Plot Plan for:	Owner: Griswold Kristen G	Lot: 30
	Address: 4565 Cassidy St	Scale: 1"=20'
Submitted by:	Subdivision: Bradley Ranch	Additional Information:: Champion Window Company of Colorado Springs_Griswold_5050003115
	Parcel/Locator: 6511212006

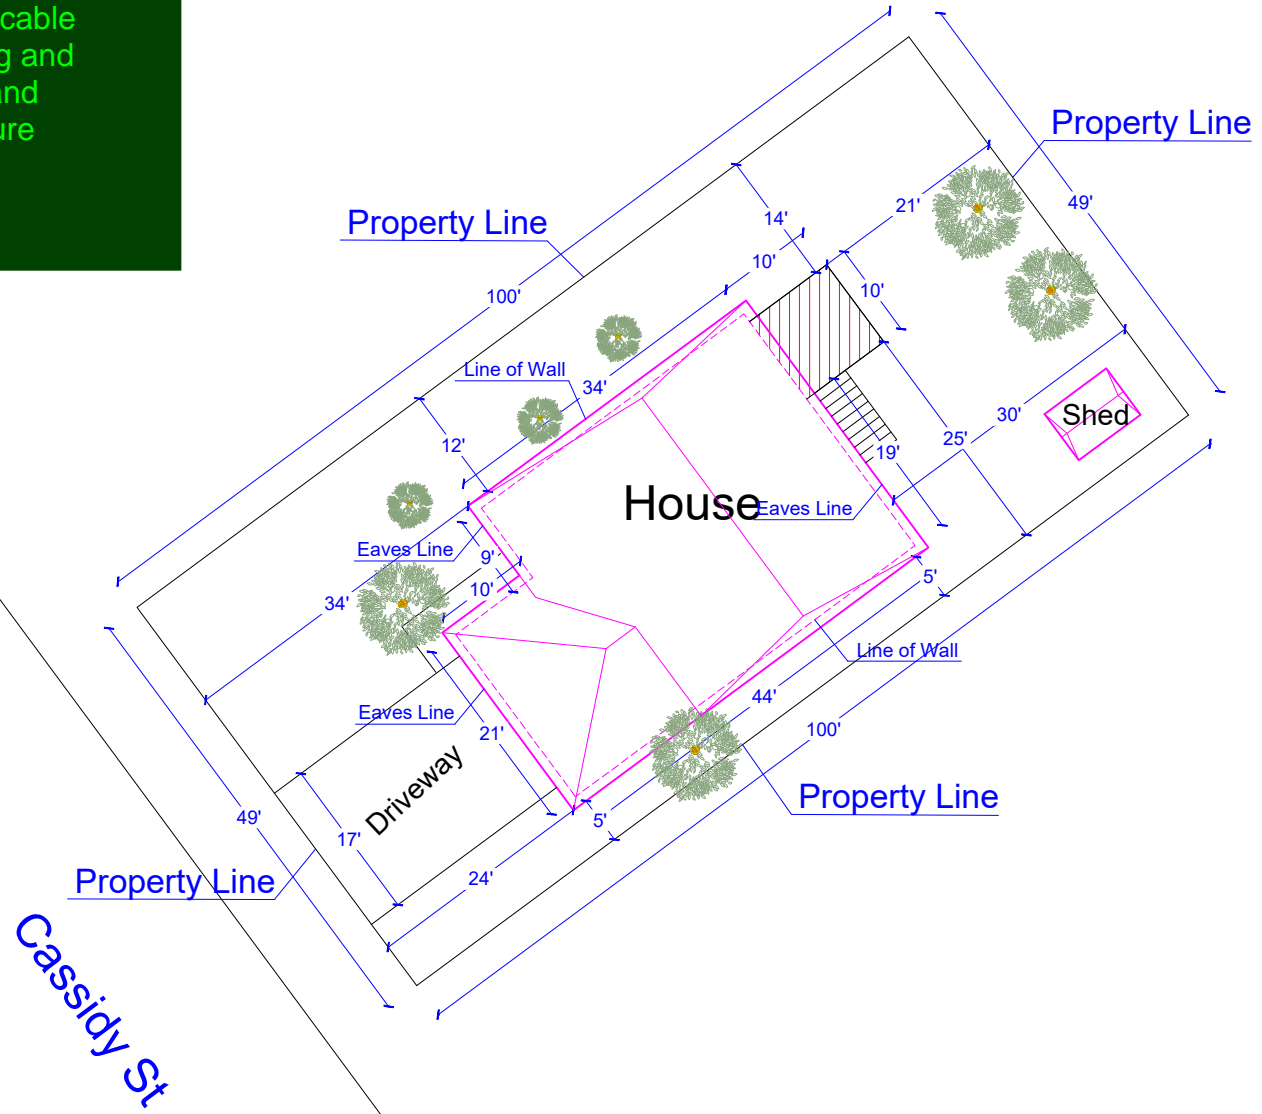
Please include lot area calculation

Please include the following or address in the letter of intent:

- Date, north arrow, and a graphic scale
- Any rights-of-way
- Any easements
- Location of all sidewalks, trails, fences and walls, retaining walls, or berms
- Location of existing and proposed water and wastewater infrastructure, including well and septic location, if applicable
- Location of all existing and proposed utility lines and associated infrastructure
